# Errata Sheet

## **2008 Edition of SCDOT's Access and Roadside Management Standards**

*This errata sheet logs both content errors and minor implementation errors that have been identified since the release of the 2008 Edition of SCDOT's Access and Roadside Management Standards Manual. All page numbers refer to those indicated on the document pages and not the PDF formatted text. The corrected pages are included in this document.*

FIGURE A-6

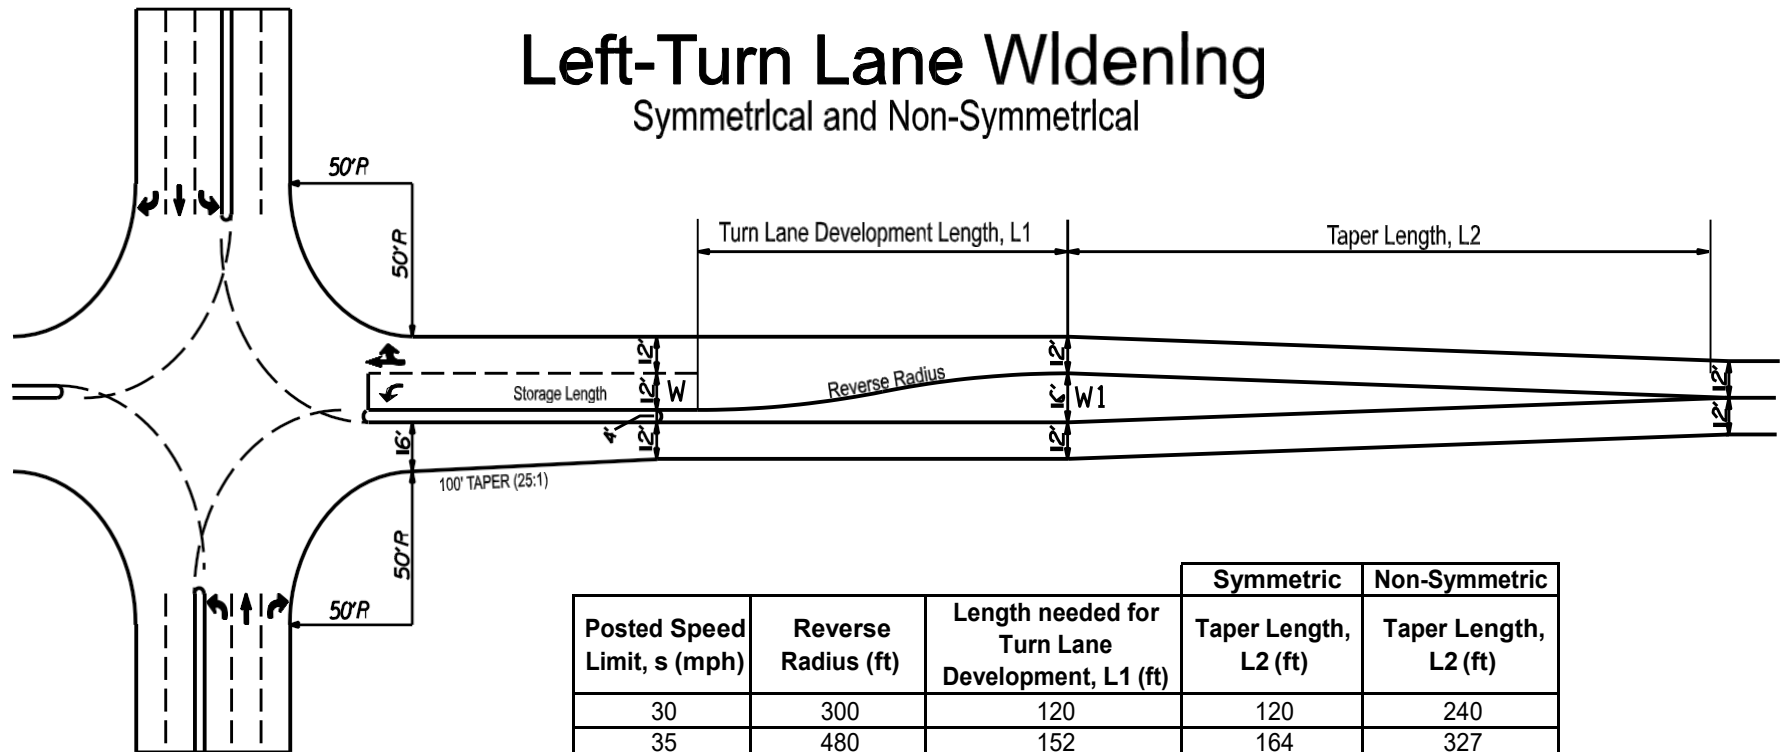
<b>Subsection</b>	<b>Page</b>	<b>Description of Correction</b>
Appendix A	A-6	Added *Algebraic Difference to the figure to define the maximum sag and crest break.
Appendix A	A-8	Corrected pavement markings for westbound approach.
Appendix B	B-1	The District 3 Office address should be 252 South Pleasantburg Drive, Greenville, SC 29607
Appendix F	F-1	The gross leasable area for the shopping center land use should be 3,000 sq. ft.
1A-3	6	Removed 57,500 Gallons fuel saved from Table 1-1
1B	7	Updated references to SC Code of Laws
3C-1	27	Figure 3-7 : Updated Middle Column title to read "Minimum Driveway Spacing (ft) on roadways with AADT $\geq$ 2000 or Driveways Generating more than 50 Peak Hour Trips"
5D-4	49	Added "Storage" to the title captions of Tables 5-8 and 5-9 and removed "deceleration length" from the 2 <sup>nd</sup> sentence of the section
5D-5	51	First sentence – Changed "from 1 to 6 feet" to "to 1 to 6 feet" to match text found in the South Carolina Highway Design Manual

Figure 3-9: Corner Clearances

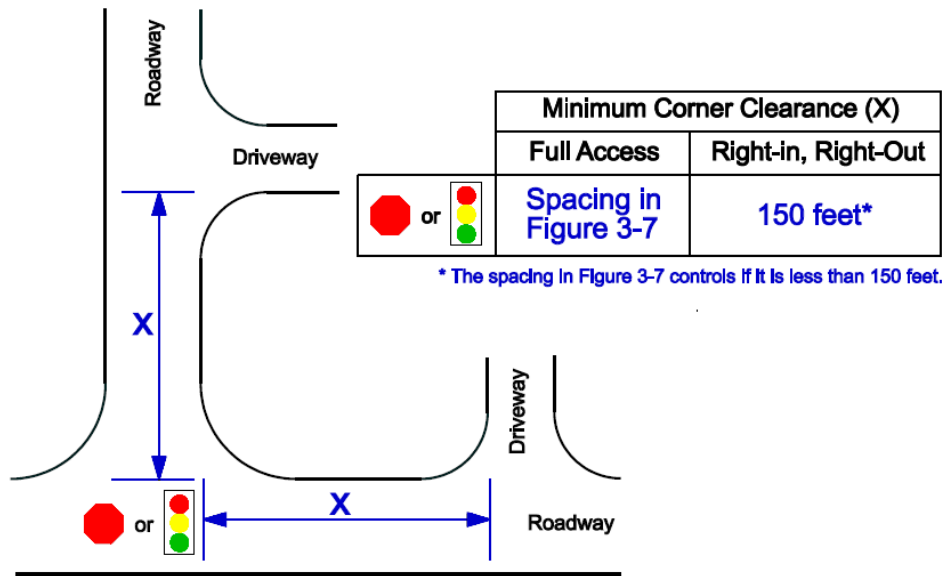
<b>Subsection</b>	<b>Page</b>	<b>Description of Correction</b>
3C-2	28-29	Modified text and Figure 3-9 to clarify the spacing requirements for right-in, right-out access.
